DESIGN REVIEW COMMITTEE

June 21, 2023 6:00 PM

AGENDA

DATE: April 14, 2023
TO: Tonya Hutson
FROM: Lynn Patterson
RE: **Design Review – 522 Oak Drive, Revised**

SINGLE FAMILY RENOVATION EXISTING SITE PLAN	
PROJECT NUMBER:	OR20BE23
DATE:	MARCH 13, 2023
DRAWN BY:	AW
REVISION #:	-
A-102.1	
SCALE:	1" = 10'-0"

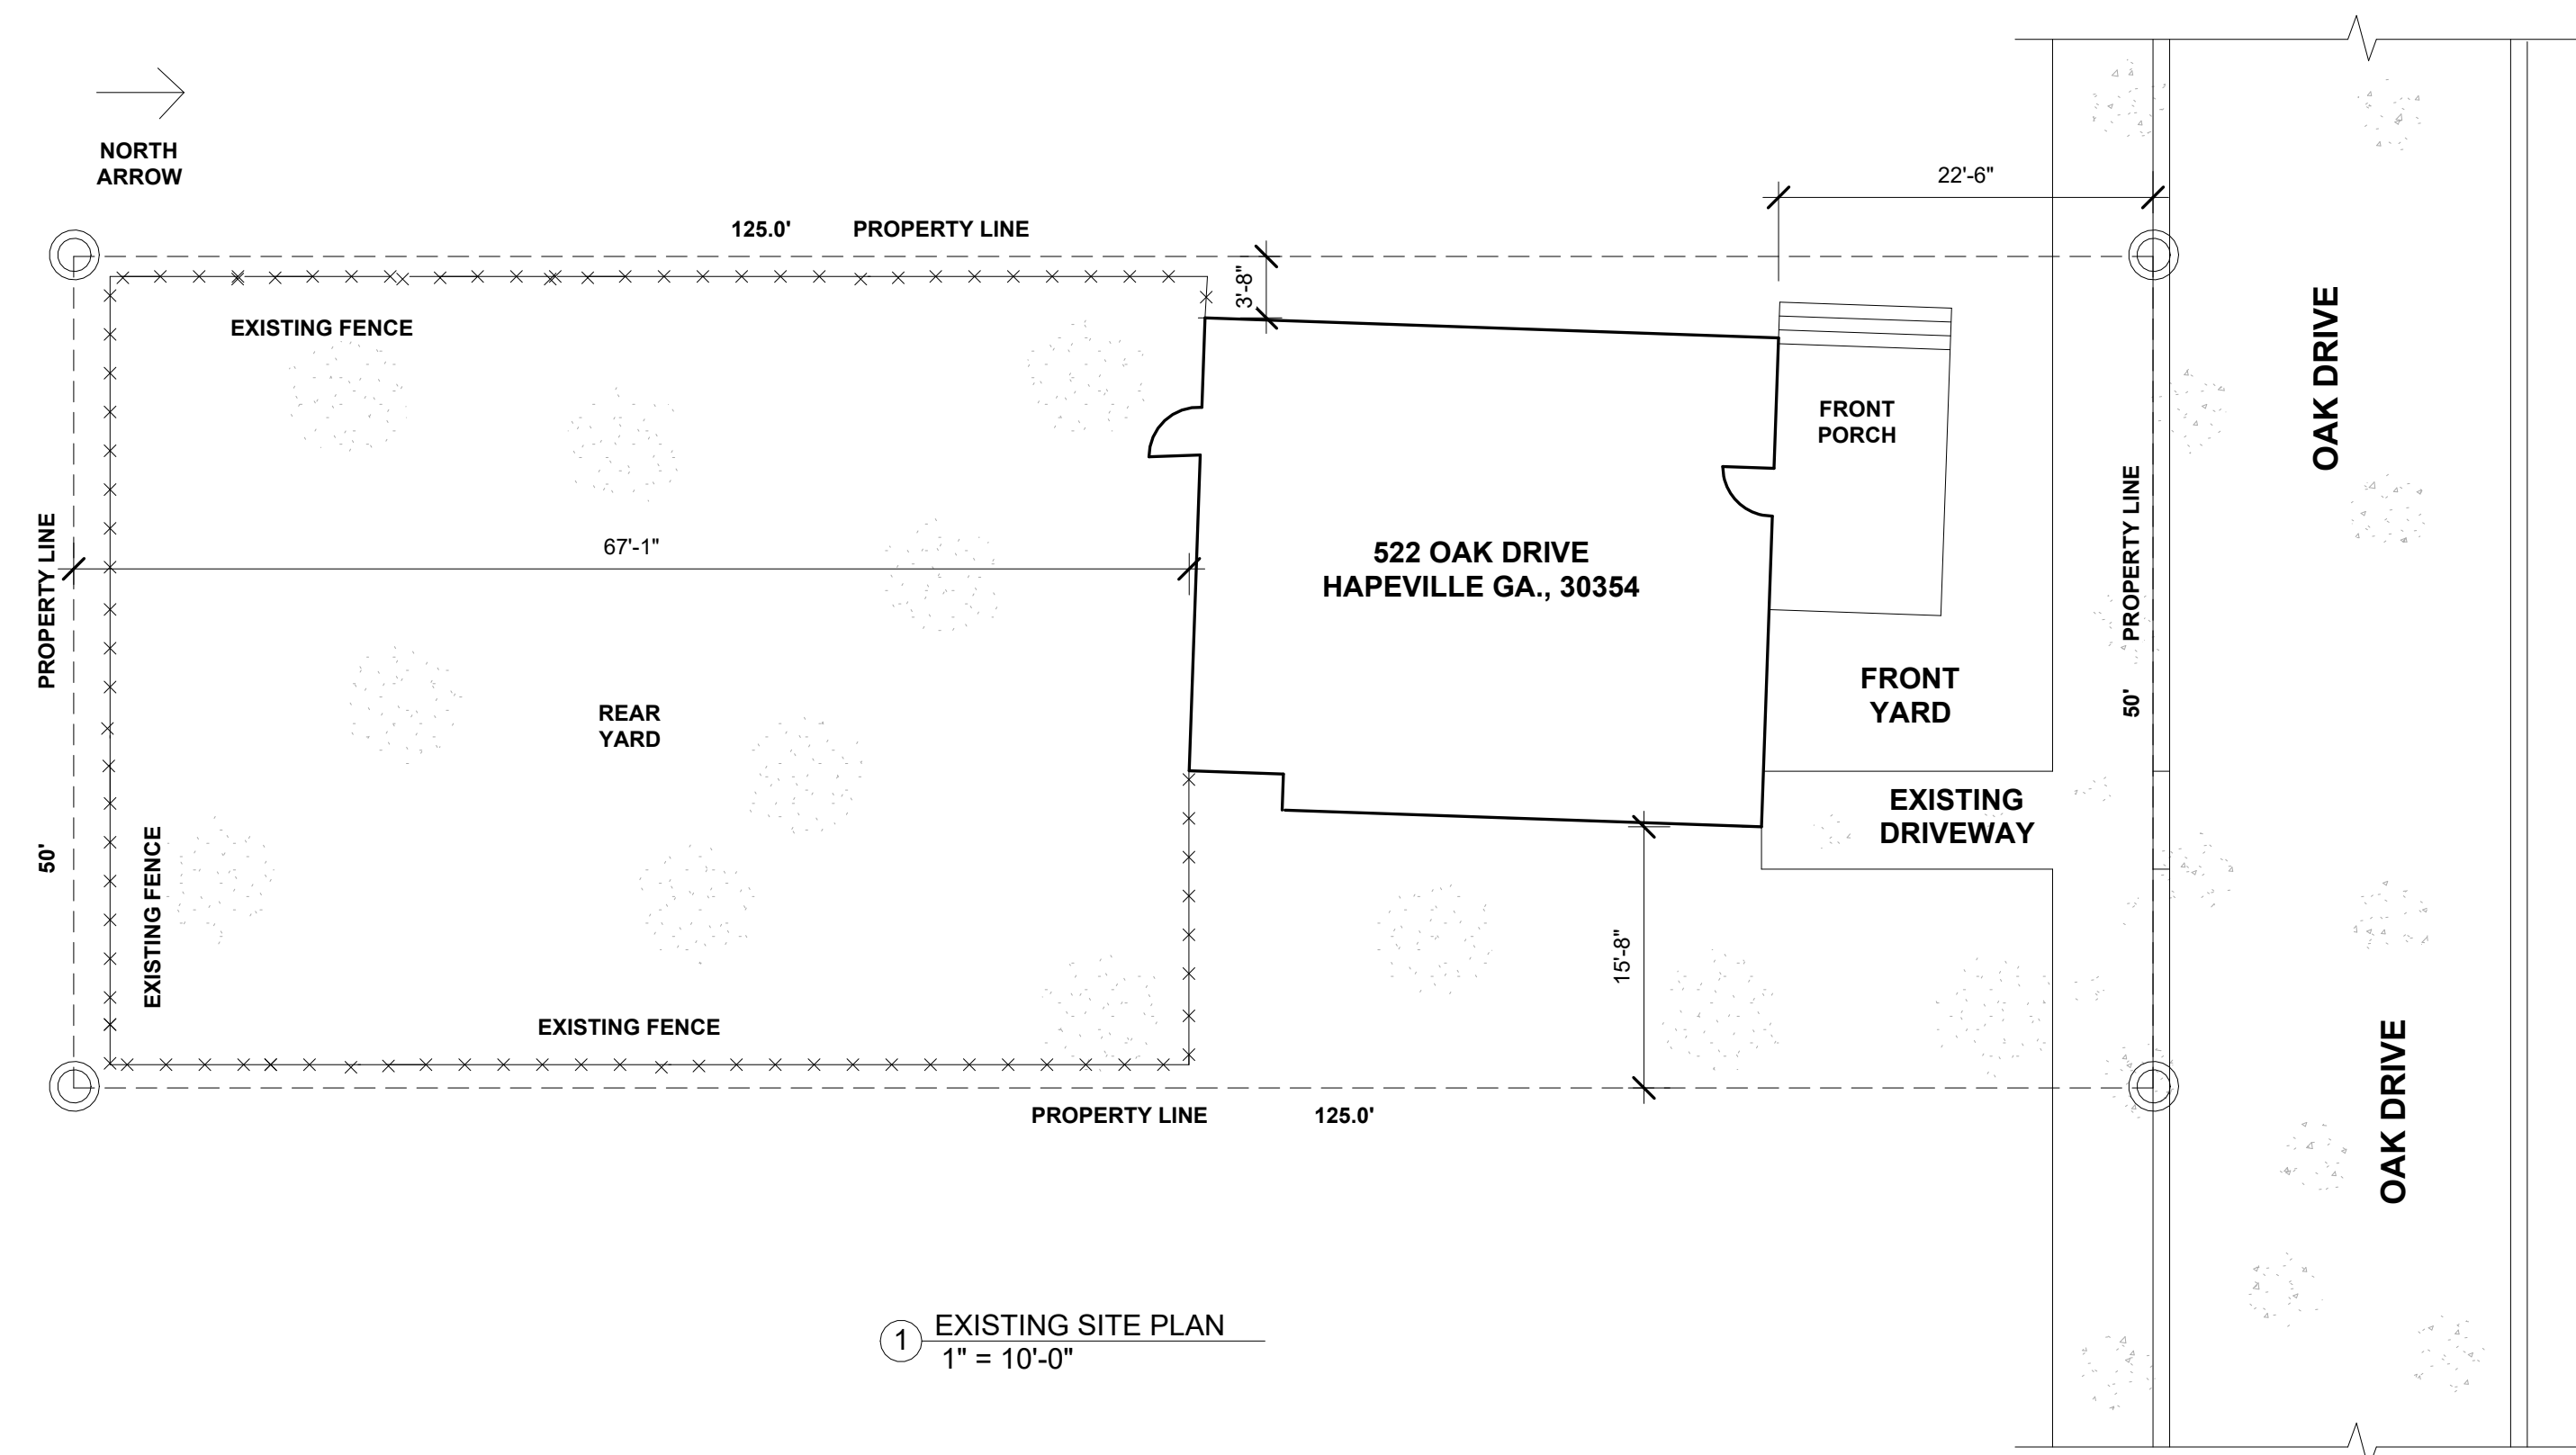
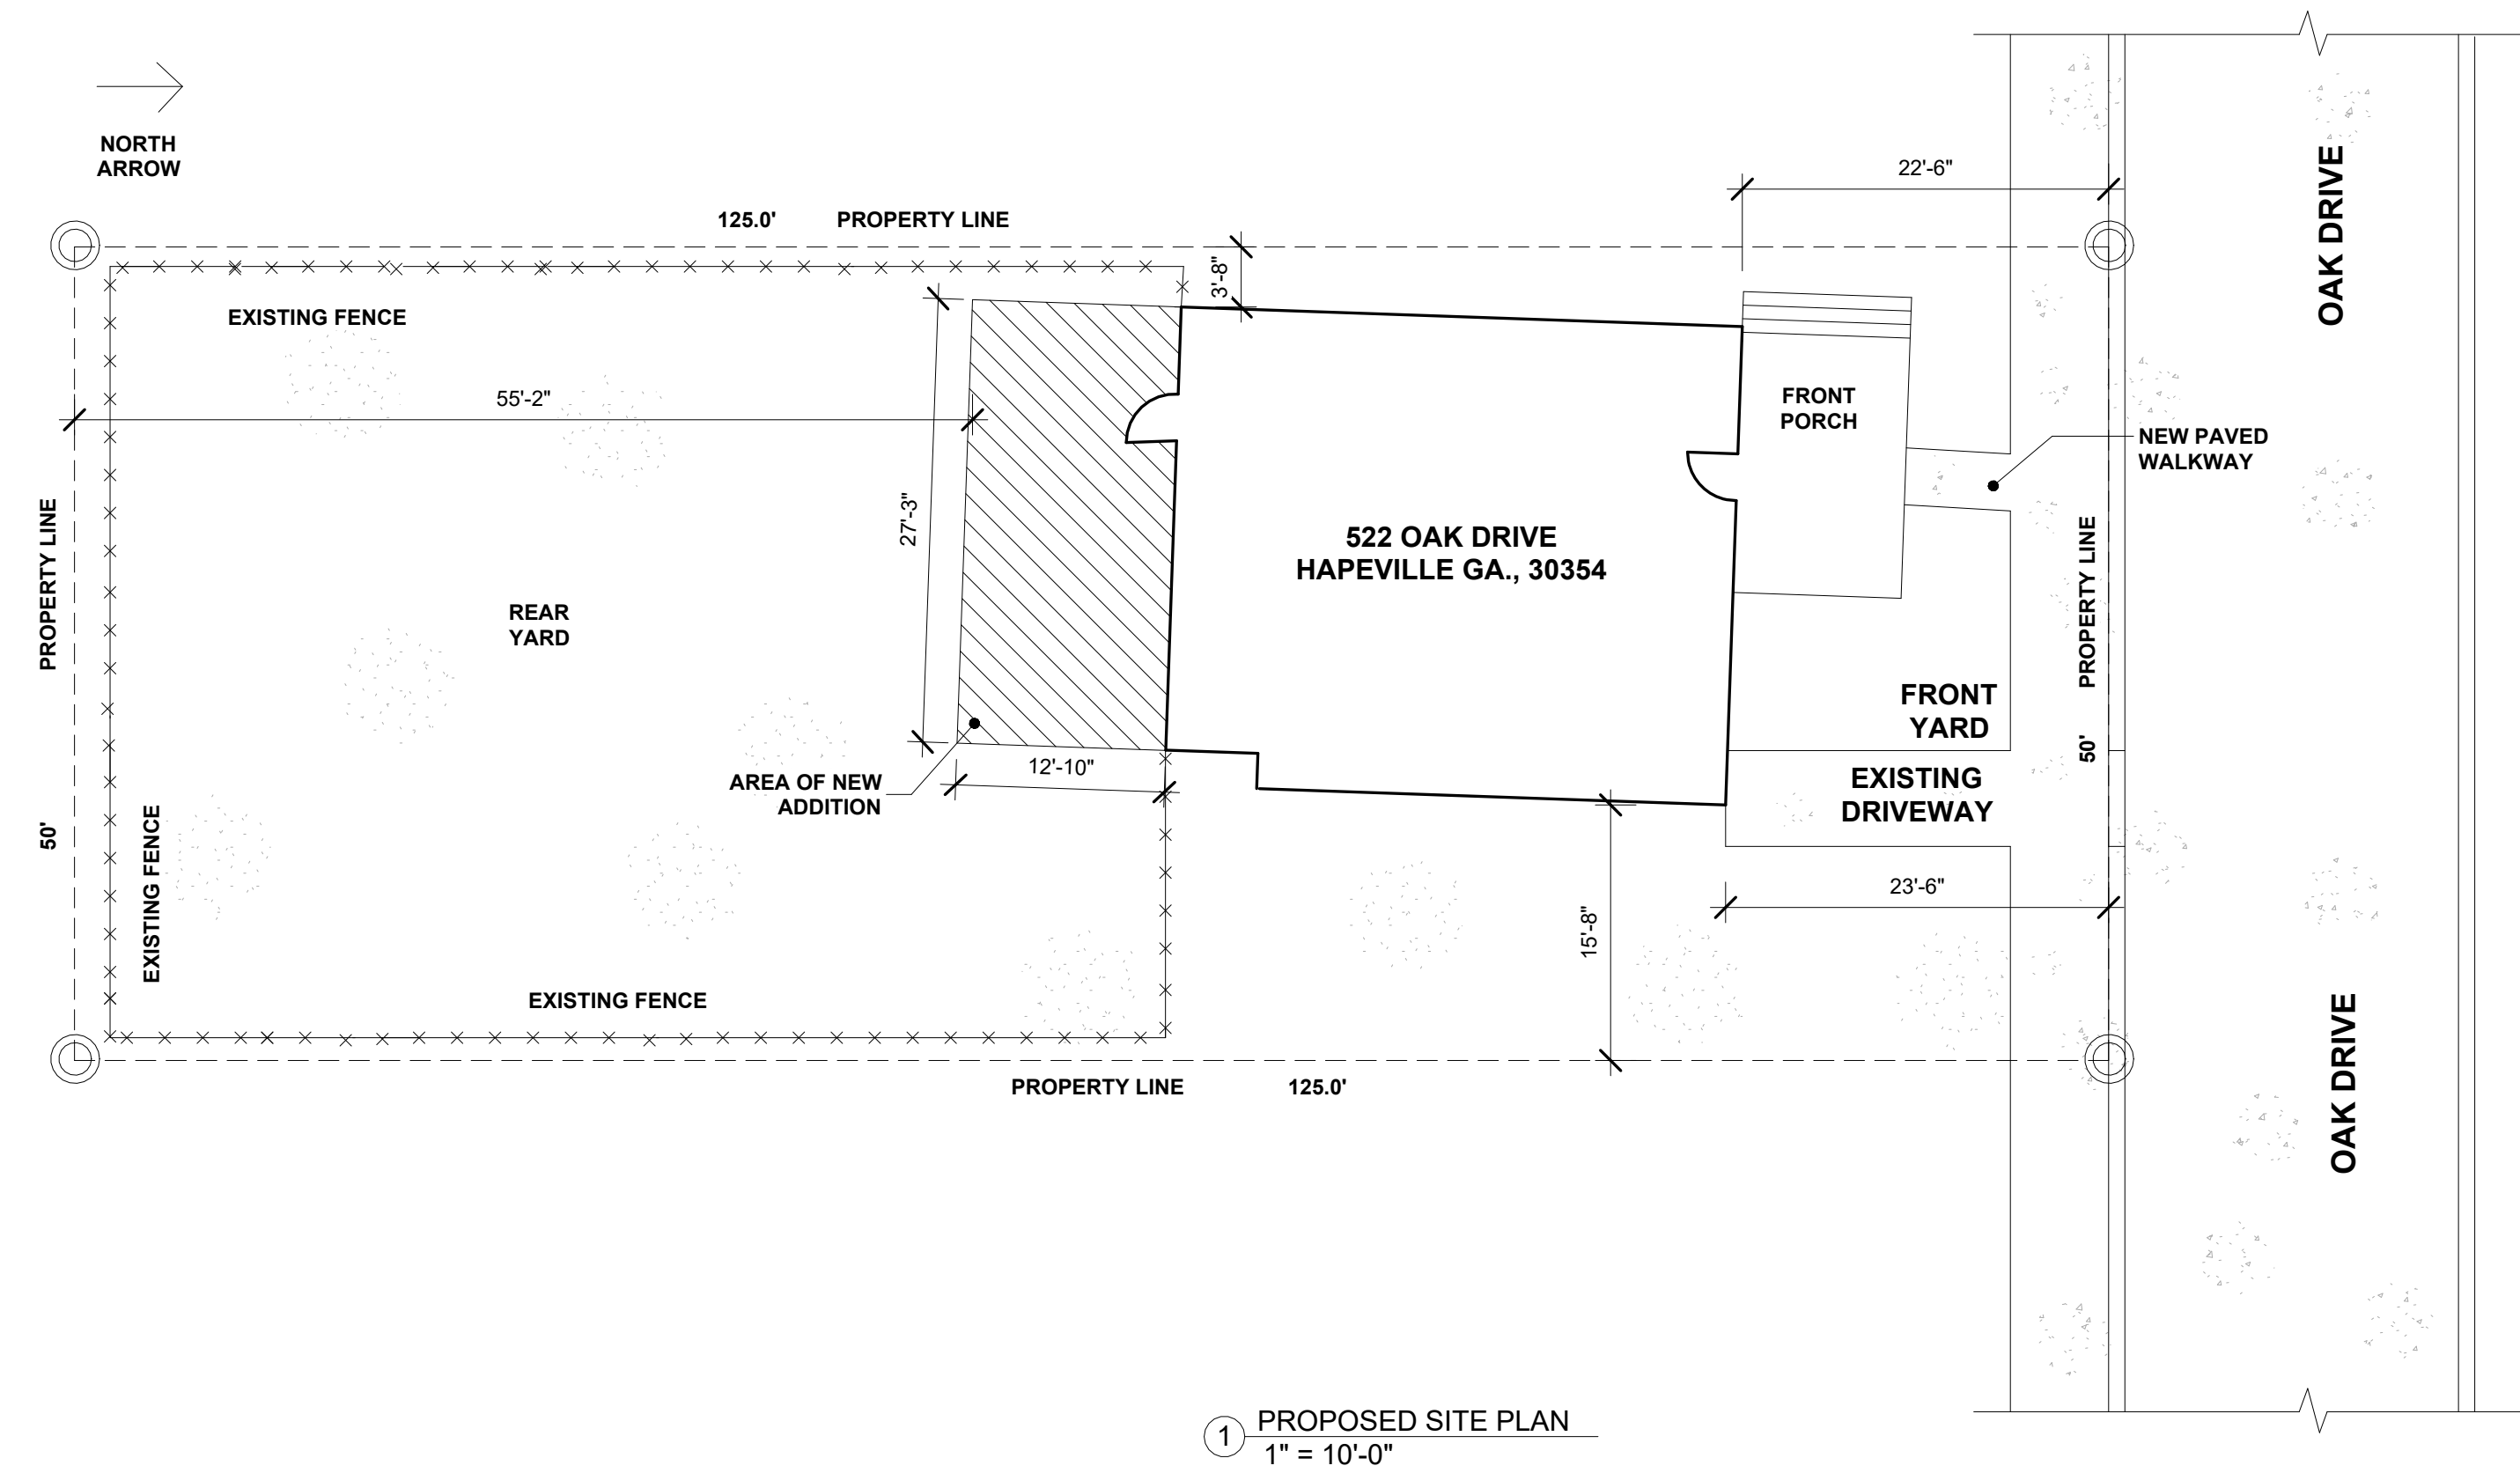
*An incorrect site plan was submitted with the application. The correct site plan should be provided to the City as part of this application.

STAFF COMMENT: A tree is required in the front yard. There is an existing 3' high chain link fence that extends into the supplemental area along the side yard (west property line)

STAFF COMMENT: There is an existing parking pad in the supplemental area (dimensions not provided). The side setback is 13' which would allow for a driveway along the side of the house using most of the existing curb cut.

- Per the survey, there is an existing 3' high chain link fence that extends into the supplemental area along the side yard (west property line). This should be removed. The site plan shows the fence further back. Chain link should not be visible from the right of way.

- The location of mechanical screening should be shown. Provide details for screening.
- The light indicated in the application is not shown on plans.
- There is an existing parking pad in the supplemental area (dimensions not provided). The side setback is 13' which would allow for a driveway along the side of the house using most of the existing curb cut.
